**SPECIALIST STUDY: NOISE IMPACT ASSESSMENT: PROPOSED SOETWATER WIND ENERGY FACILITY NEAR SUTHERLAND: CHANGE OF LAYOUT AND WIND TURBINE DETAILS**

The above-mentioned issue as well as report ACED-HV/NIS/201202-Rev 0 is of relevance.

Figure 1: Sound power emission levels of the V90 wind turbine used in the original noise impact assessment versus the new V136 wind turbine

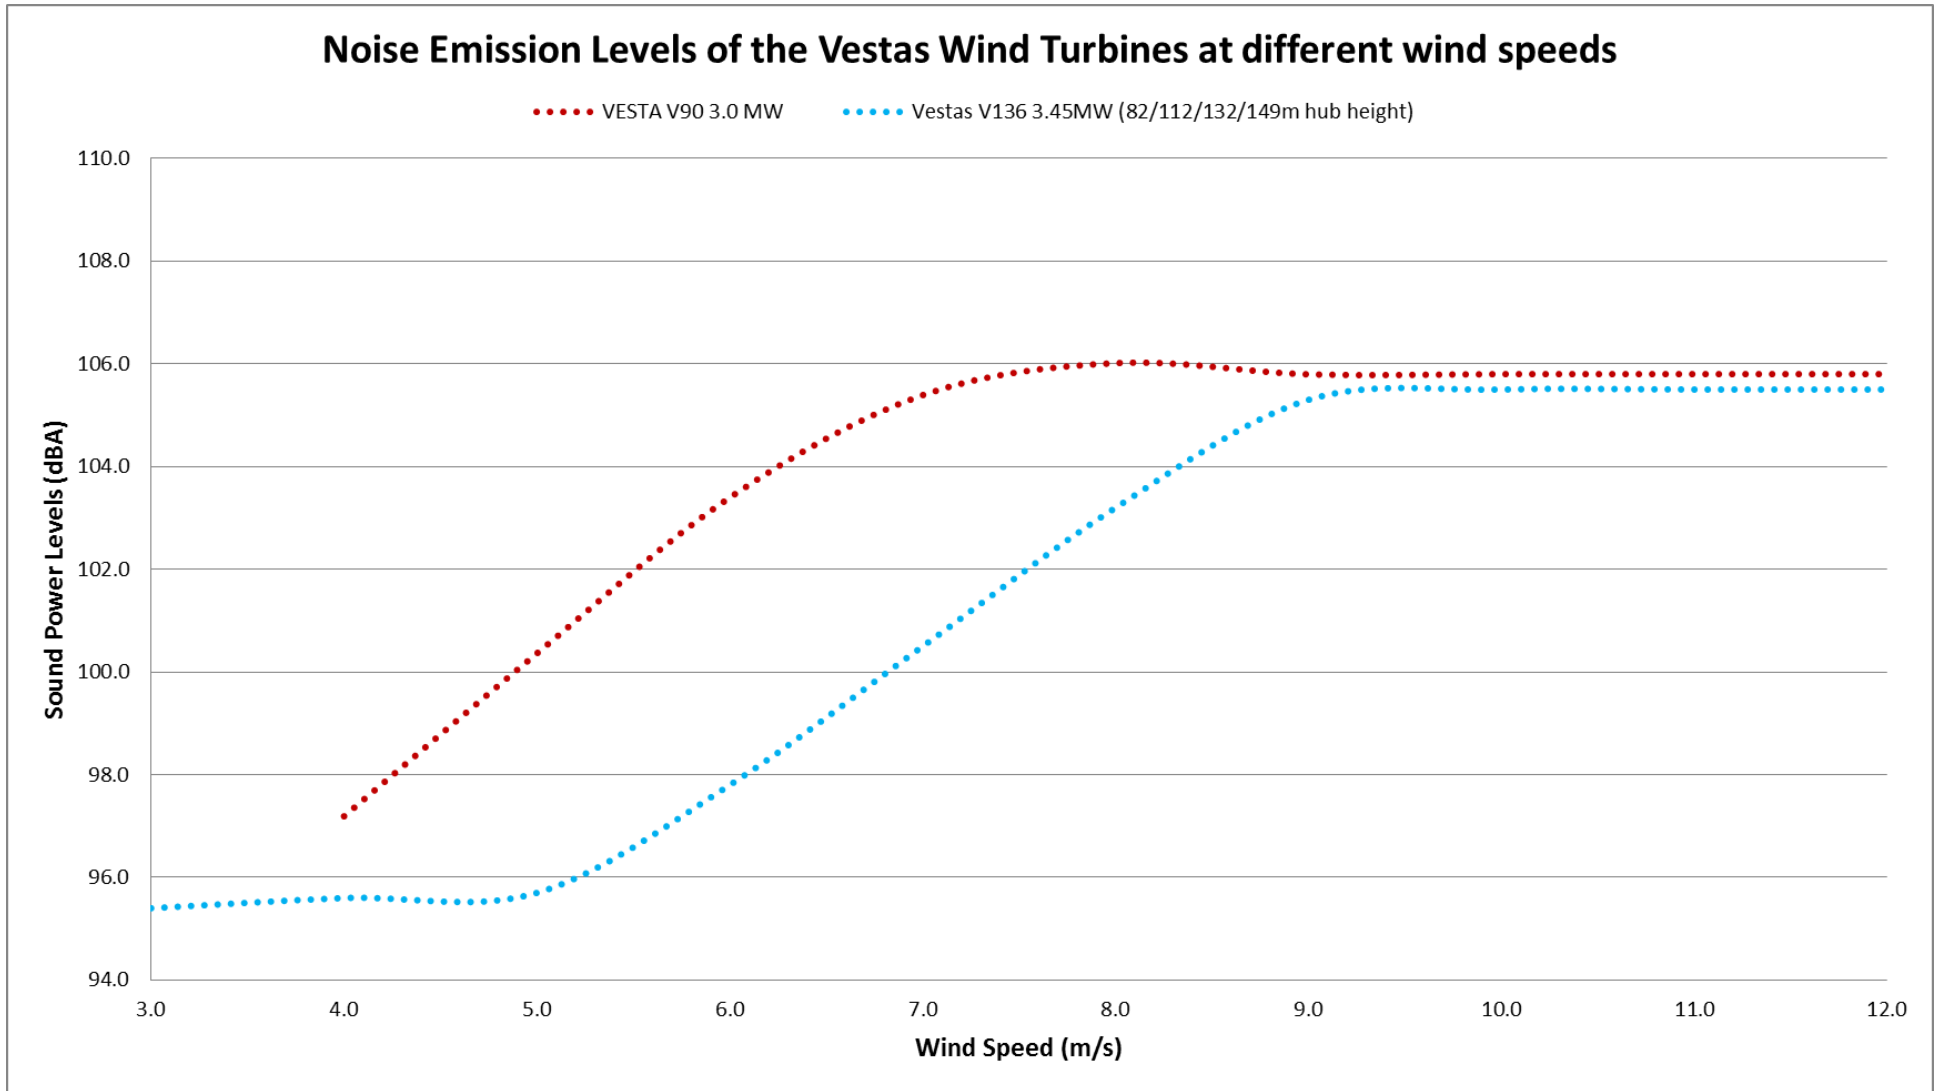
The developer also proposes to use the Vestas V136 wind turbine (generating power up to 4.5 MW with a rotor diameter of up to 150m) with a hub height of up to 120m. The sound power emission levels of the Vestas V90 (original study) and V136 (new proposed) wind turbine are illustrated in **Figure 1**.

Considering the maximum sound power emission level of 105.5 dBA, making use of the proposed Vestas V136 wind turbine may slightly reduce the noise rating levels at the closest noise-sensitive receptors.

Considering the slight adjustment to the wind turbine positions and the potential noise impact, it is my opinion that the change will not increase the significance of the noise impact. It will therefore not be required to do new noise propagation modeling or update the previous noise impact assessment. The findings and recommendations as contained in the previous document will still be valid.
